# Access Compliance Report Public Rights-of-Way (Curb Ramps)

**Main Street:** MAGNOLIA\_AVE      **Cross Street:** BIXBY\_AVE      **Location:** NW

**ADA ID:** RPAT210924130141      **Ramp Type:** Type 4 - Parallel      **Initial Pass/Fail:** Fail      **Overall Compliance:** No      **Severity Score:** 16

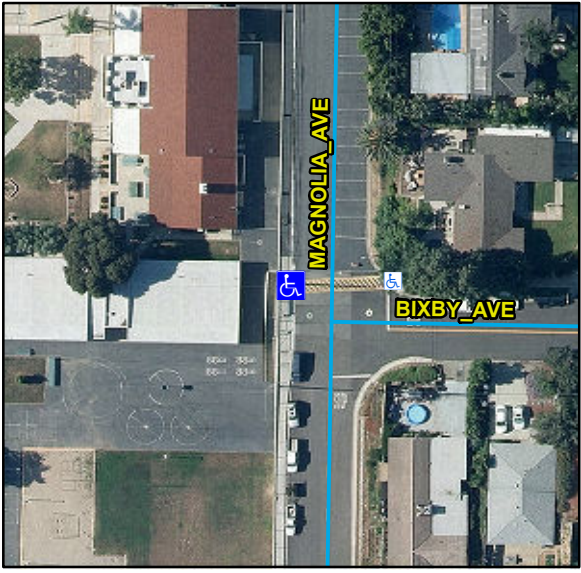
Compliance	Description	Data	Compliance	Description	Data
N/A	Ramp Length LT (in)	72	N/A	Ramp Length RT (in)	73
Yes	Ramp Width LT (in)	83	Yes	Ramp Width RT (in)	83
No	Ramp Run Slope LT (%)	10.2	Yes	Ramp Run Slope RT (%)	7.1
Yes	Ramp Cross Slope LT (%)	0.8	Yes	Ramp Cross Slope RT (%)	2
N/A	Landing Present	N/A	N/A	DWS Provided	N/A
N/A	Landing Length (in)	N/A	N/A	DWS Contrast	N/A
N/A	Landing Width (in)	N/A	N/A	DWS Length (in)	N/A
N/A	Landing Run Slope (%)	N/A	N/A	DWS Full Width	N/A
N/A	Landing Cross Slope (%)	N/A		DWS Offset Type	N/A
N/A	Landing Movement Obstructed?	N/A	N/A	DWS Offset Left (in)	N/A
	Landing Movement Type	N/A	N/A	DWS Offset Right (in)	N/A
N/A	Landing Shared	N/A			
N/A	Clear Space	N/A			
N/A	Clear Space To Crosswalk (in)	N/A			
N/A	Marked Crosswalk 1	Yes	N/A	Marked Crosswalk 2	N/A
	Crossing 1 Direction	E		Crossing 2 Direction	N/A
N/A	Marked Crosswalk 1 Width (in)	84		Marked Crosswalk 2 Width (in)	N/A

**Possible Solutions:**  
**Remove & Replace Entire Ramp.**

**OC Std/PROW:**  
**R304.3.2, STD 1115**
